Planning & Zoning Board

Thursday, June 4, 2026

Summit Crossing – Major Site Plan, Preliminary Plat, Variance Requests

City Planning Staff Comments:

Upper Floor Assembly Plan

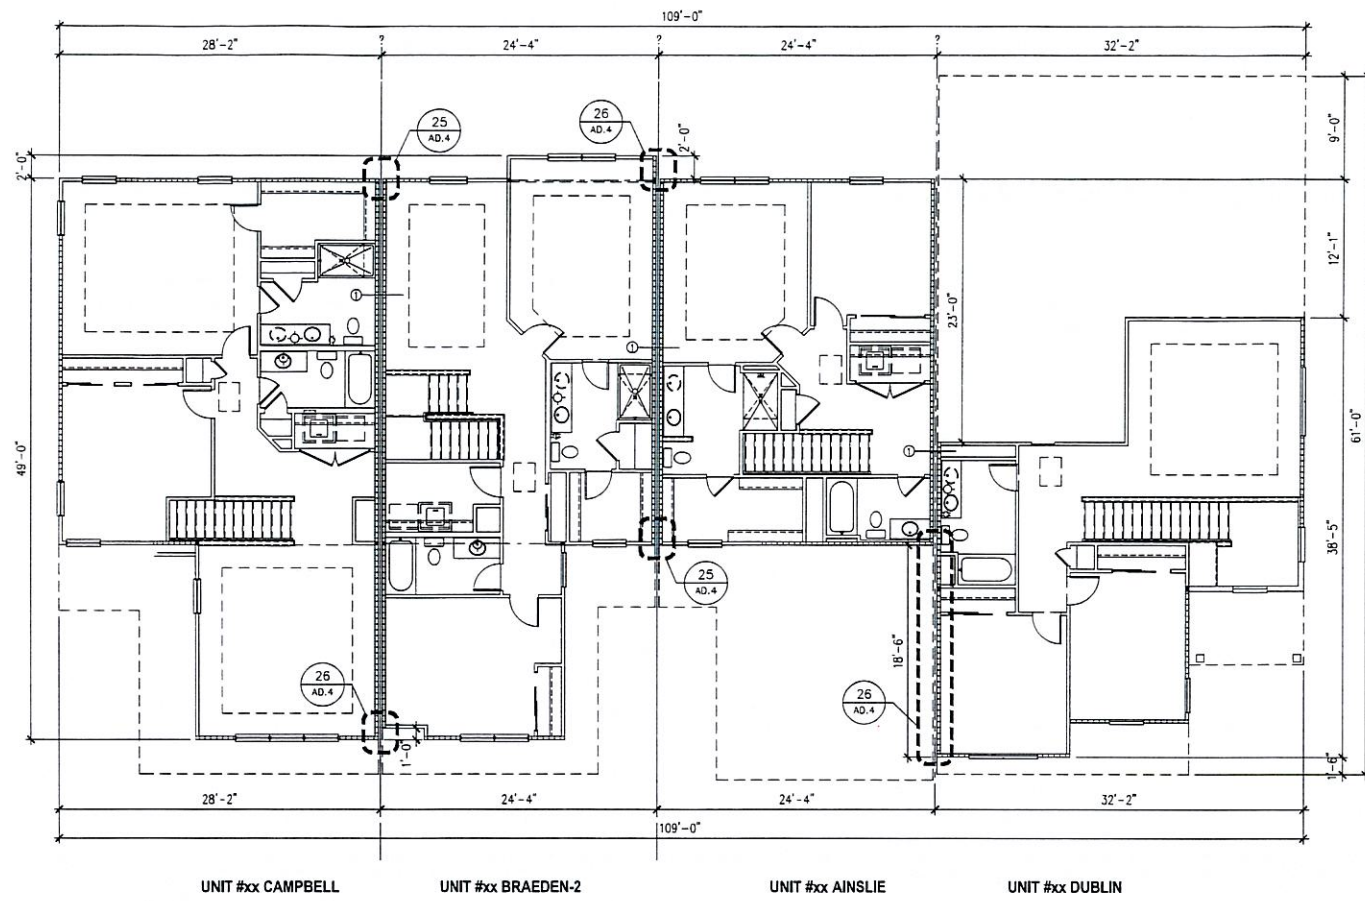
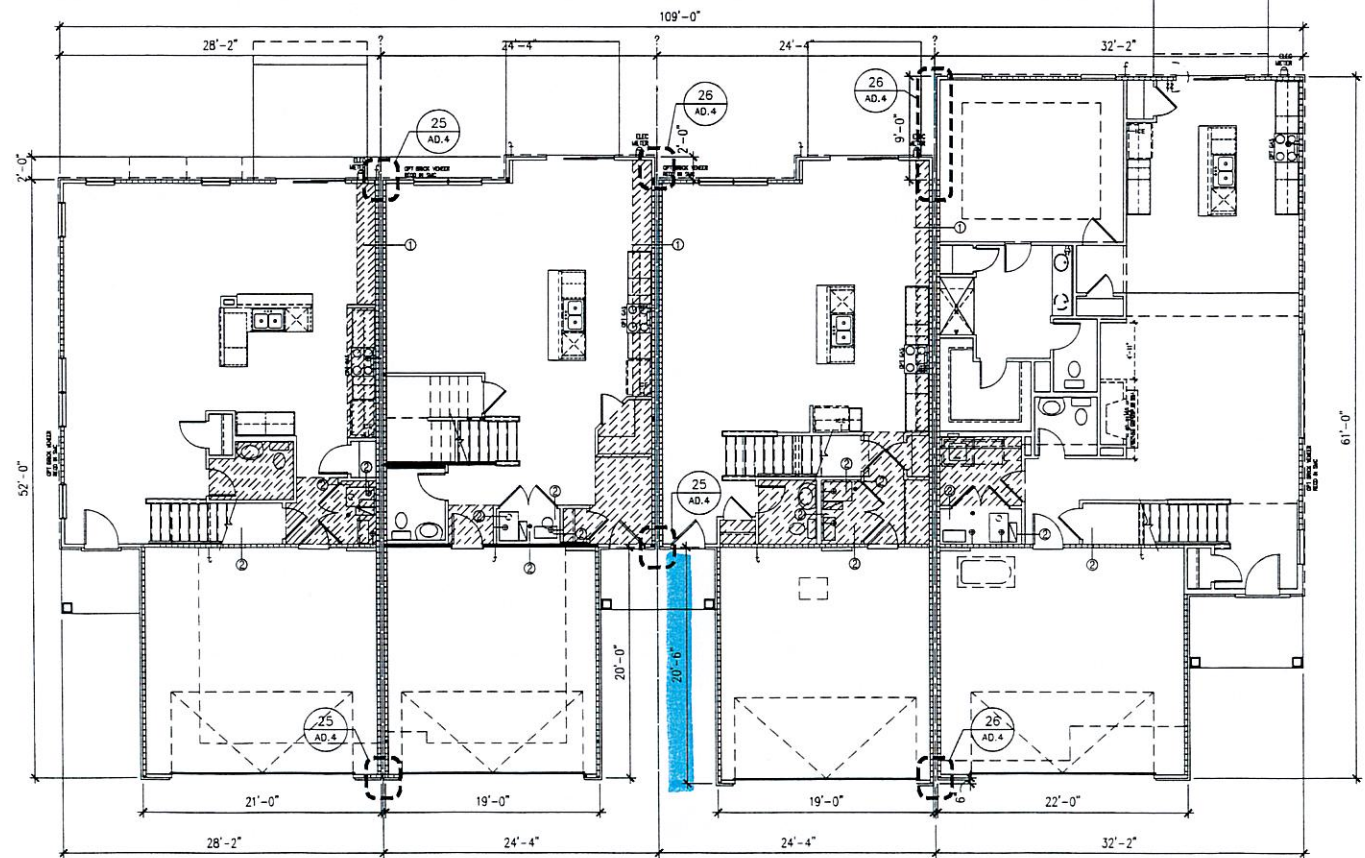
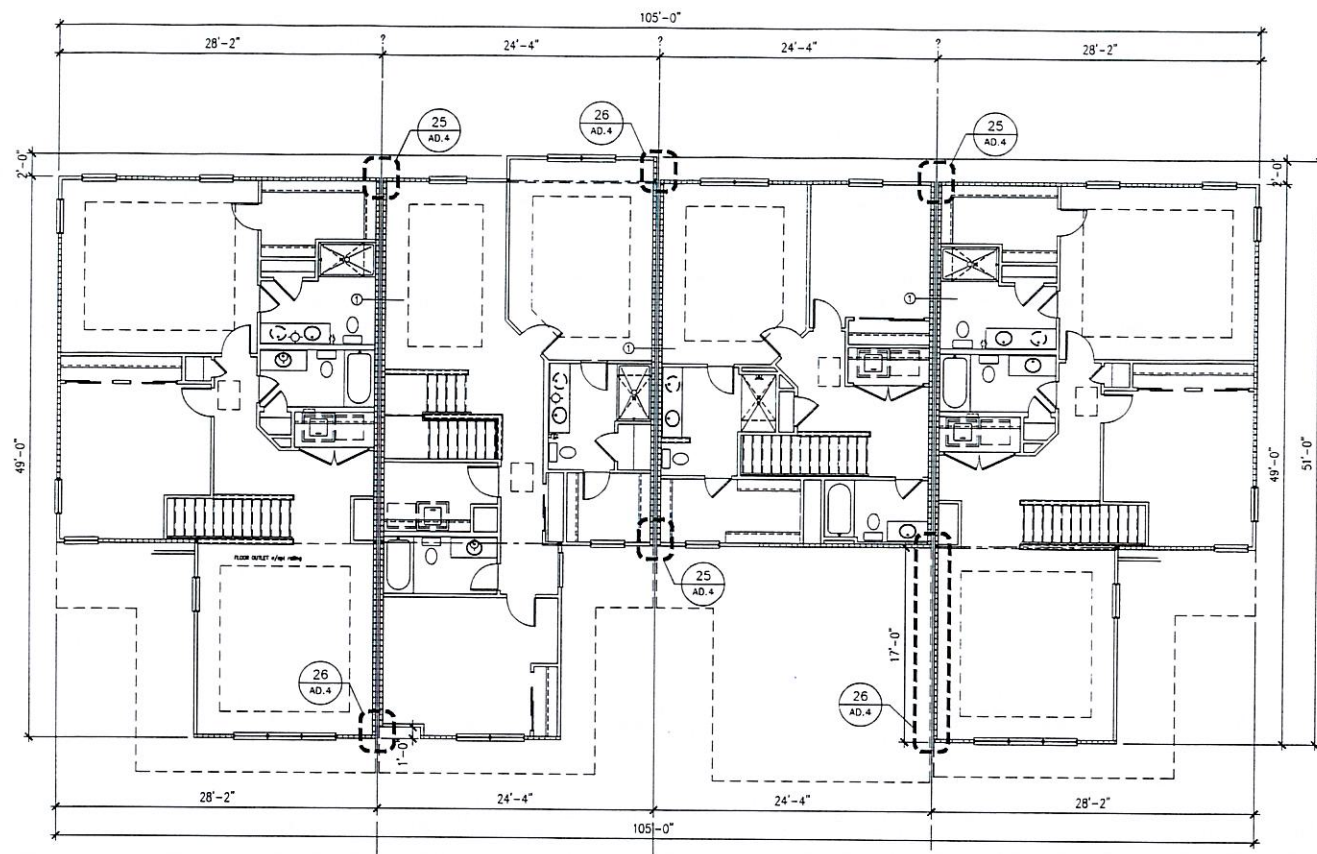
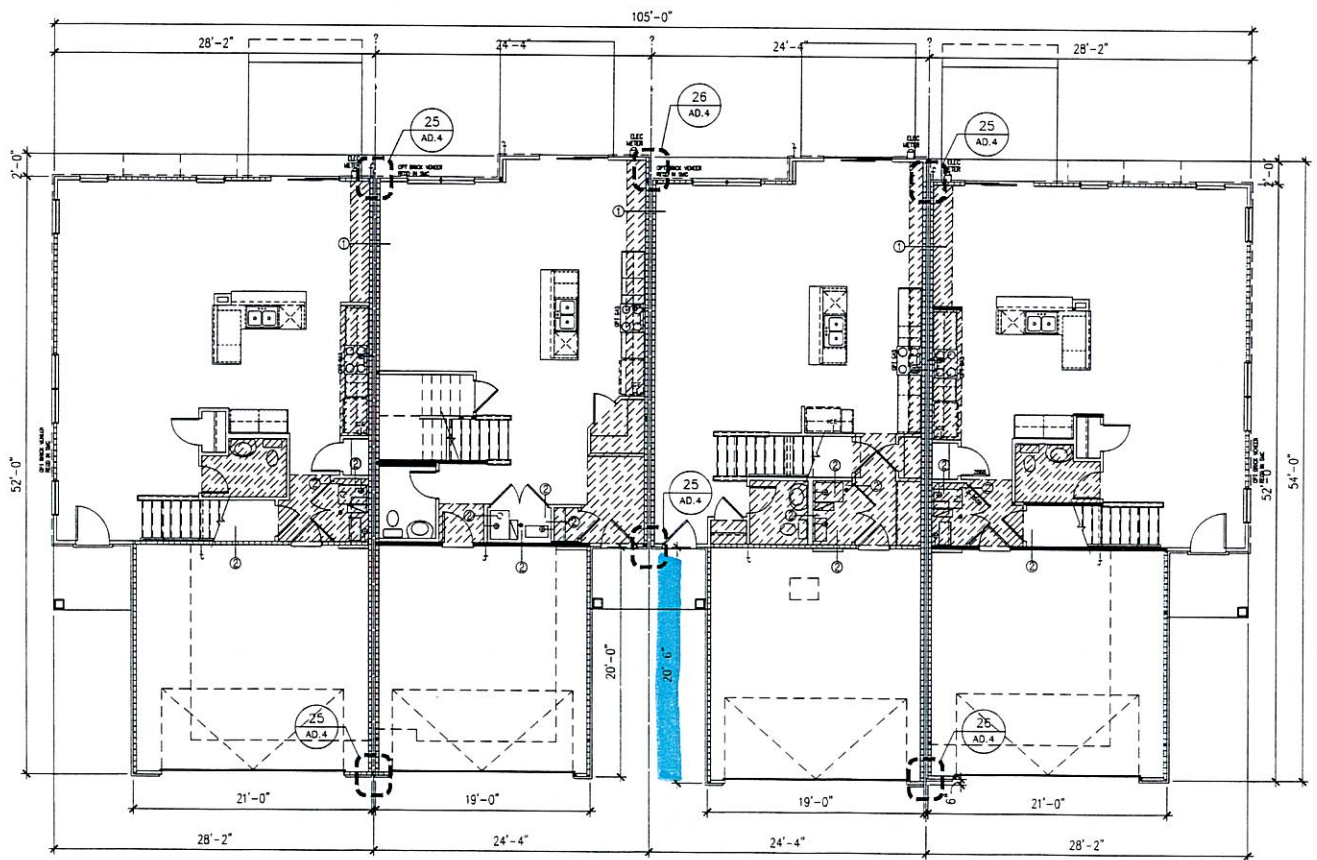
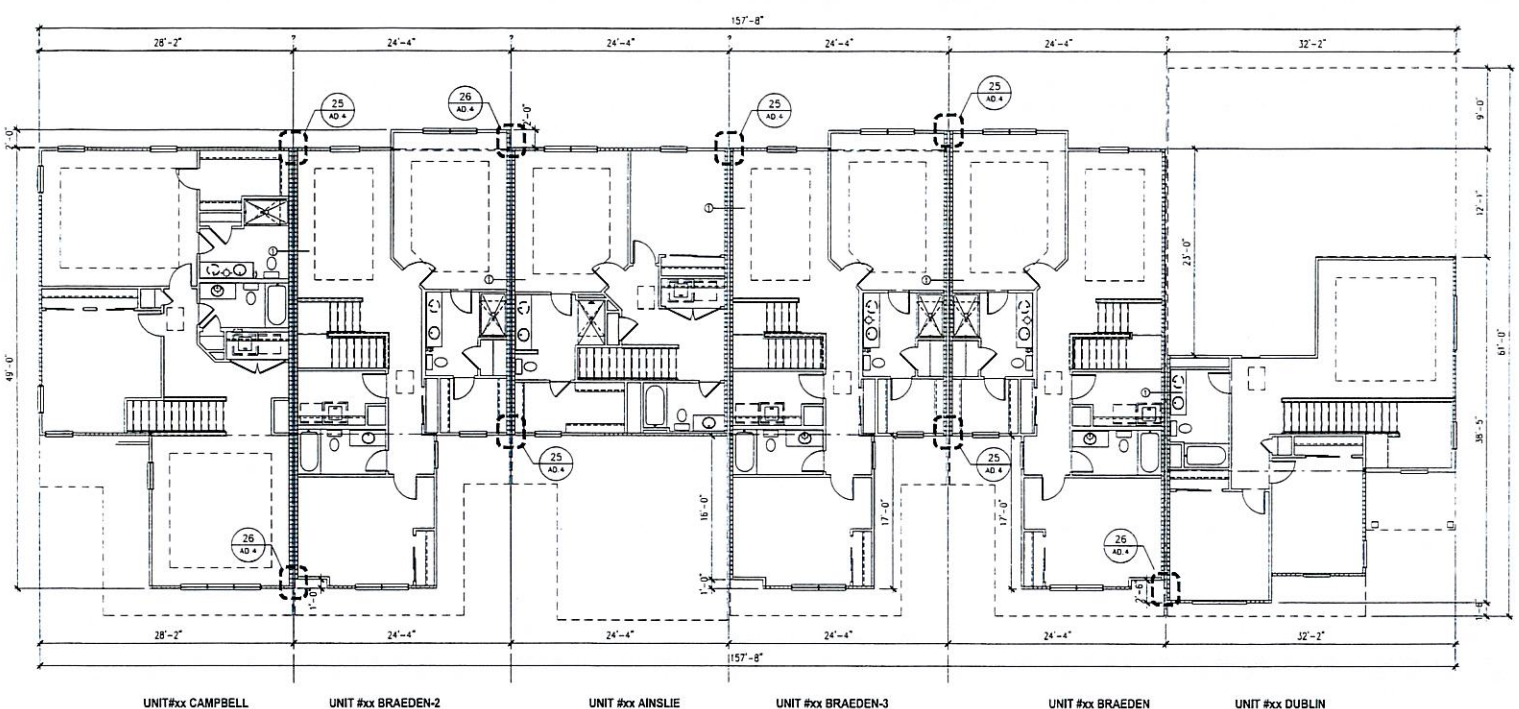
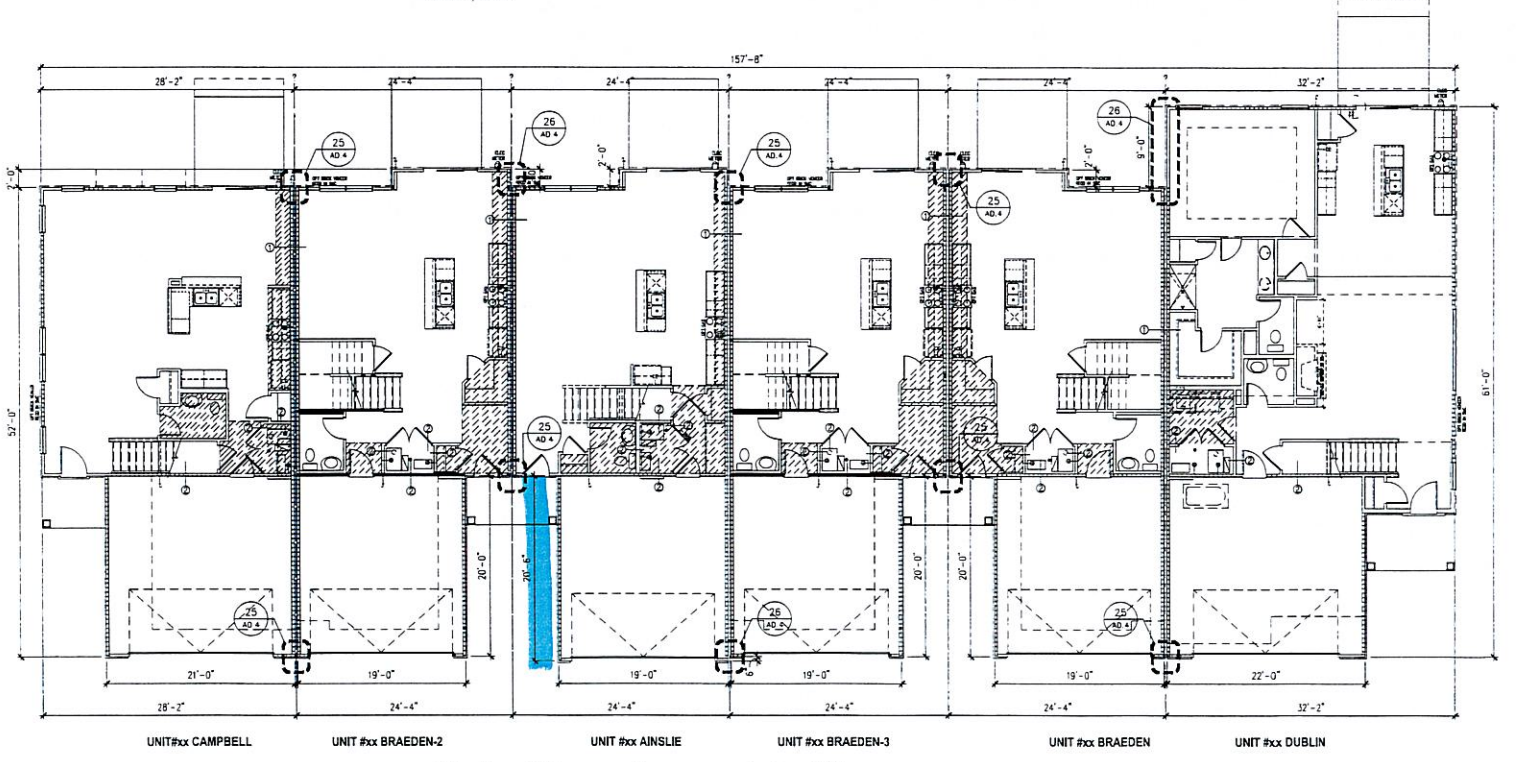
2. The applicant is requesting a variance to allow the garage to extend an additional 12 feet 6 inches more than the permitted 8 feet from the building's front façade. The applicant has provided in the packet, elevations/floor assembly plans providing three different units (not including the Ainslie unit) with six different options within those units that could meet the requirement, and not need a variance. The applicant has also submitted a four-unit design that has been approved by zoning that meets the requirement for which this variance has been submitted. The applicant has not stated how this particular unit has some type of special circumstance or condition that would deprive the property owner of the reasonable use of land, since they have other options and designs that meet this requirement.

2. During the Major Site Plan review process, staff provided comments to the applicant regarding the images shown in the submittal, requesting that the applicant give more detailed design information to ensure all residential design standards for each unit were met. That there was not enough information provide in the application for staff to review to ensure all design standards were met, and if the residential design standards were not met during their new build submittal process, a variance would be needed. (See Townhome MSP Images and Disposition of Comments - Comment #71, page 14 of 31 in the supporting document). The applicant responded with “All proposed buildings shall comply with the existing zoning”. Therefore, staff accepted the applicant’s response comments with staffs understanding that during the new build application process, the residential design standards would be met. This is due to the applicant stating that the elevations provided in the packet were subject to change and did not represent an exact representation of the intended townhome on the site, and their response stating that they would comply with existing zoning standards. Staff is of the opinion that the hardship was not created due to the strict application of the code, but that the applicant was made aware of the residential design standards and has self-created this hardship by not meeting the residential design standards that they were made aware of and acknowledge in their response letter to staff during the Major Site Plan application process.

The applicant is requesting a variance from Section 1105.06.D.ii to allow 27 lots within the development to have a garage that extend an additional 12.6 feet more than the permitted 8 feet from the front façade of the structure for a total of 20.6 feet. The applicant states that this unit, requiring the variance, was indicated throughout the Rezoning and Major Site Plan process. The parcels identified by the applicant have never been through the rezoning process within the City of Reynoldsburg. The townhome elevations provided by the applicant in the Major Site Plan, stated that the color images were a rendering to convey a sense of scale, style and quality, but did not denote an exact representation. During the Major Site Plan review process, staff asked the applicant for more detailed information regarding their townhome units due to the disclaimers provided by the applicant, to ensure all residential design standards would be met. The applicant responded to City Staff's comment and concern by stating that all zoning requirements would be
